UNITED STATES PATENT AND TRADEMARK OFFICE

APPLICATION NO.	FILING DATE	FIRST NAMED INVENTOR	ATTORNEY DOCKET NO.	CONFIRMATION NO.
08/851,465	05/05/1997	EDGAR C. ROBINSON	INT21246	5986

Office Action Summary	Application No.	Applicant(s)	
	08/851,465	ROBINSON ET AL.	
	Examiner	Art Unit	
	AVINASH SAVANI	3749

DETAILED ACTION

20. Segment of Fig. 1 of Nutten (the examiner has added the lead arrows and text appearing below).

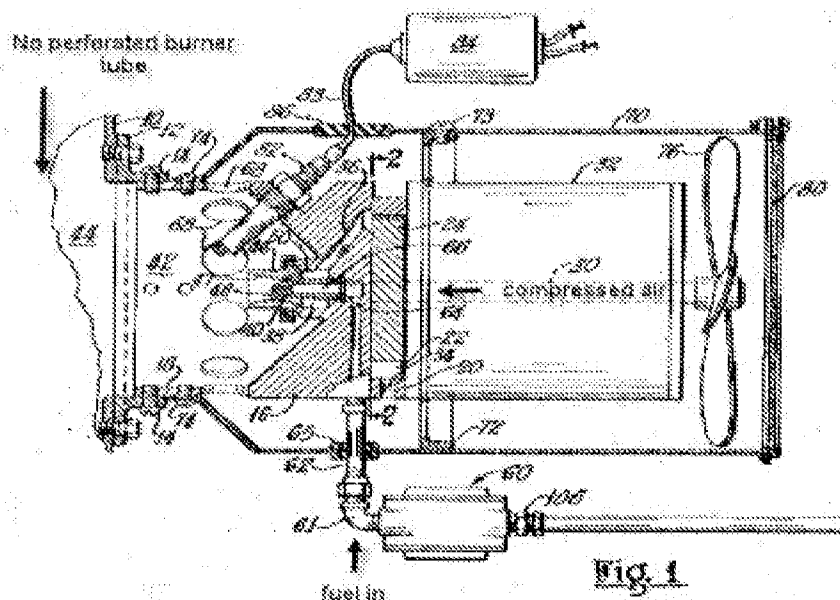
19. Therefore, in regard to claim 1,2, and 4-8, it would have been obvious to a person of ordinary skill in the art at the time the invention was made to modify the burner tube of Nutten to be formed as a perforated burner tube, thus allowing Nutten to operate as an infrared burner, as shown in Patrick as infrared fuel burners are recognized for their cleanliness and efficiency (see Bennett, col. 3, lines 15-17), and in the case of liquid fuel burners, operation of a burner as an infrared burner to minimize the possibility of flame quenching since combustion in these types of burners occurs against an incandescent surface of the burner, which is generally at a temperature of 1600 to 2500 degrees Fahrenheit and is above the quenching temperatures (see Bennett, col. 3, lines 23-27).

22. As discussed and above and illustrated in the segments of applicant's Fig. 5A and Nutten's Fig. 1, Nutten discloses all the elements of applicant's claim 1 with the exception of a burner tube with a perforated outer surface rendering the burner an "infrared burner." However, the examiner has pointed to Patrick showing the use of a perforated burner tube in the burner art forming an "infrared burner." The following is a segment of Fig. 7 of Patrick which is disclosed as being an infrared liquid fuel burner (next page):

21. Rotated Copy of Applicant's Fig. 5A (the examiner has added the lead arrow and "perforated burner tube" text appearing below).

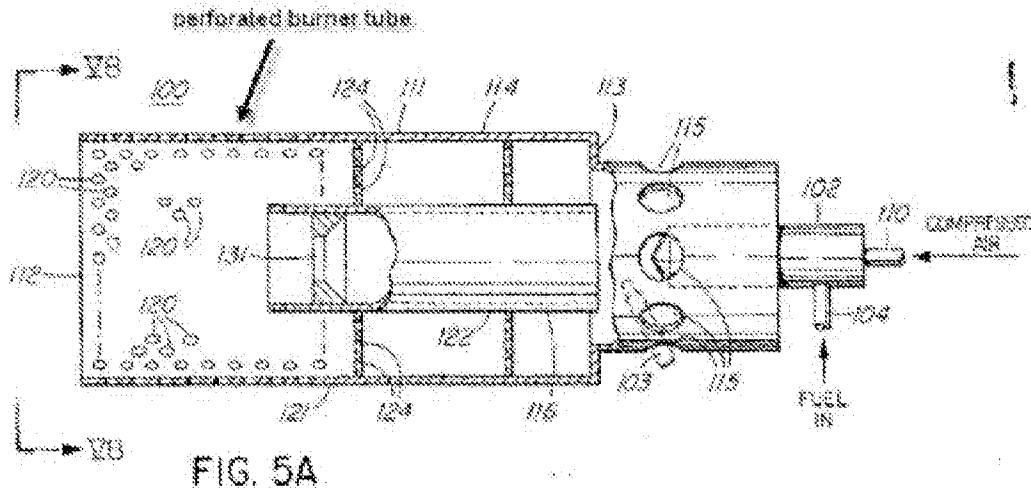
3. Claims 1-8 are rejected under 35 U.S.C. 112, first paragraph, because the specification, while being enabling for the teaching of a perforated burner tube downstream of the nozzle, does not reasonably provide enablement for the limitation that the perforations are located "immediately adjacent" the nozzle. Figure 5A, for example, shows perforations (120) at a distance spaced from the nozzle (102). The specification does not enable any person skilled in the art to which it pertains, or with which it is most nearly connected, to make or use the invention commensurate in scope with these claims.

5. As discussed above, claim 1 has been amended to include the recitation of perforations which are located "immediately adjacent" the nozzle. However, it is unclear from the claim if the perforations are intended to be the openings shown in the sides of the burner tube (120), the perforations in spacer plates (124), or the perforations supplying air to the nozzle (115).

6. For Examination purposes, the examiner has regarded the claims as referring to the perforations in the sidewalls of the burner tube (120), but applicant is requested to clarify if the claim is intended to read on the perforations in the sideways spacing plates (124) or at the nozzle outlet (115).

23. Segment of Fig. 7 of Patrick (the examiner has added the lead arrow and text appearing below).

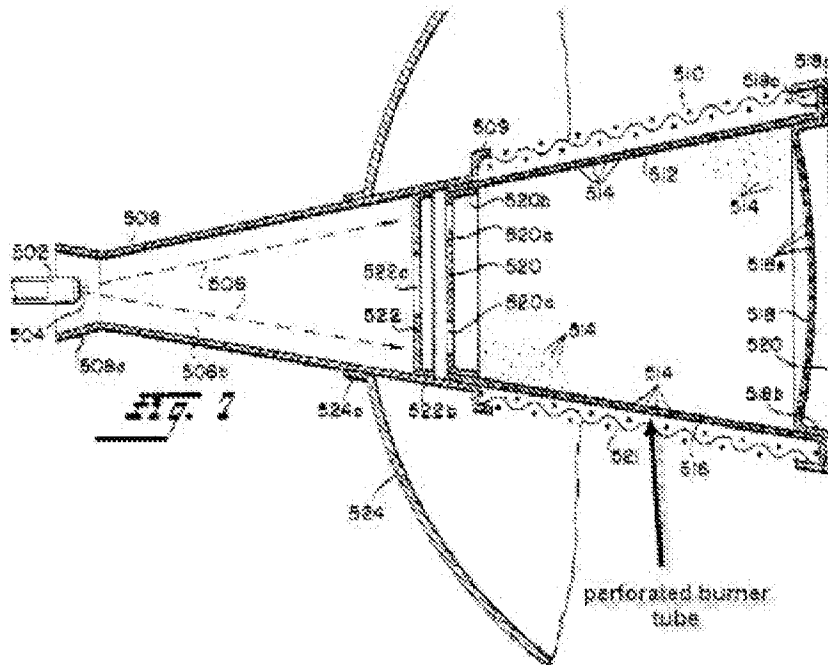
17. However, Patrick is cited to remedy this deficiency. Patrick teaches a liquid fuel fired burner that is considered analogous art to both applicant's invention and Nutten. The liquid fuel burner of Patrick is expressly noted to be an infrared burner (see col. 1, lines 8-9). This infrared burner includes a burner tube that includes a burner tube that is perforated that is typical of infrared burner assemblies (see Fig. 7 showing a burner tube 510 that includes perforations 514 and 518e in outer surfaces 512 and 518).

24. As seen in the above Figures, and noted in the above 112 rejections, the scope of the new claim limitation that the burner tube has perforations extending immediately adjacent the nozzle is unclear. However, Patrick is regarded to teach this limitation, as Patrick shows a liquid fuel nozzle (502) upstream of a perforated burner tube (514). To the extent the perforated burner tube of applicant is "immediately adjacent" the fuel nozzle, the Patrick burner tube is regarded as being "immediately adjacent" to the nozzle, as they show the same configuration.
